EL14-031b

## 2011-2017 LEAF; REPLACEMENT HIGH VOLTAGE **BATTERY PACK**

NTB14-059b

This bulletin has been amended. The Applied Vehicles and Parts Information have been revised. No other changes have been made. Please discard previous versions of this bulletin.

Figure 1

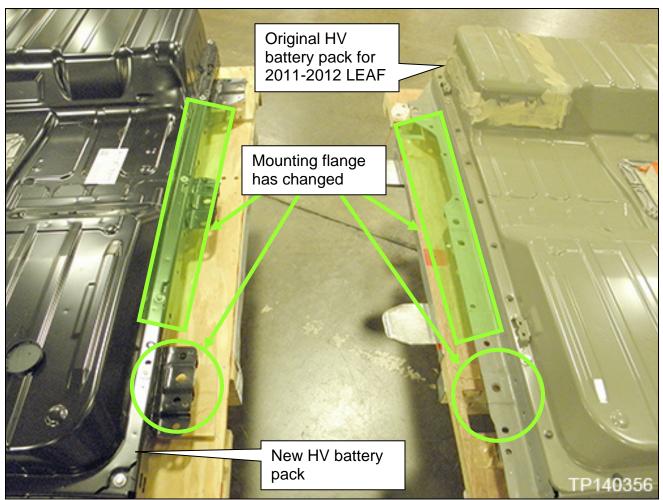
Figure 1 shows the new and old HV Battery Packs side by side.

Figure 2

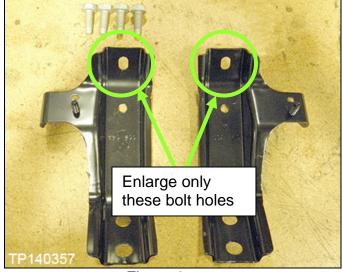
- 5. Enlarge support bracket bolt holes:
  - a. Place the support brackets in a vise one at a time.

- b. With a ½" drill bit, enlarge the bolt holes indicated in Figure 2
- c. Cover the newly exposed metal with a zinc rich paint to prevent corrosion.
  - After the paint has dried and before assembling the brackets to the new HV battery, Bitumen wax will also be applied to these areas.

Figure 4

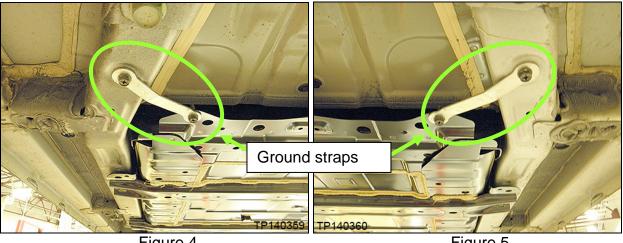
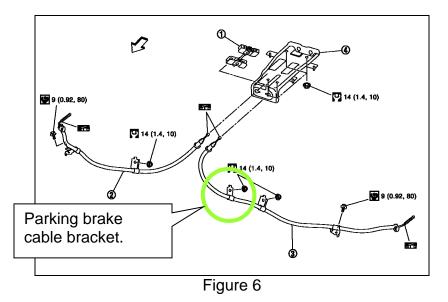
- b. Install only the front HV Battery Pack ground straps.
  - Figure 4 and Figure 5 show the front HV Battery Pack ground straps (two total). Discard the rear HV Battery Pack ground straps.

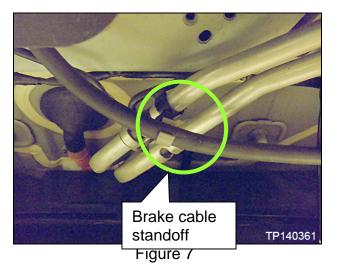
- 7. Remove the right side parking brake cable bracket (Figure 6) from the cable and discard.
  - This bracket will be replaced with the standoff in the Parts Information table.

8. Install the new brake cable standoff from the Parts Information table.

Figure 13

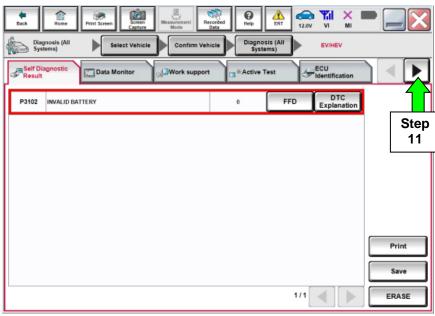
11. Select the "right arrow" (Figure 13).

**NOTE:** This arrow <u>will only</u> be available if the HV Battery registration card is installed in the CONSULT PC.

- The card must be installed before opening C-III plus.
- If the card is installed, but the arrow in Figure 13 is not available, reboot the CONSULT PC.
